# Product Change Notification

Product Change Notification: E-16-014619

AMPMODU MTE HEADERS GPL 296

**Change in circuit cavity features**

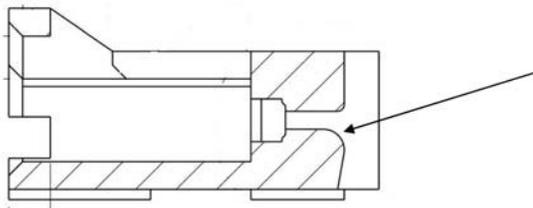
To satisfy customer demand for the capability of MTE headers to handle RoHS solder temperatures, TE Connectivity has retooled the MTE header product line to use high temperature compatible LCP molding material. These changes will result in the following product changes: 1) Housing material will change from high temperature nylon to LCP. 2) The header housing width will be reduced by 0.005 inches to accommodate the assembly process. 3) In order to consolidate some housing features, the contact cavity configuration will be changed slightly as shown in the attached sketch.
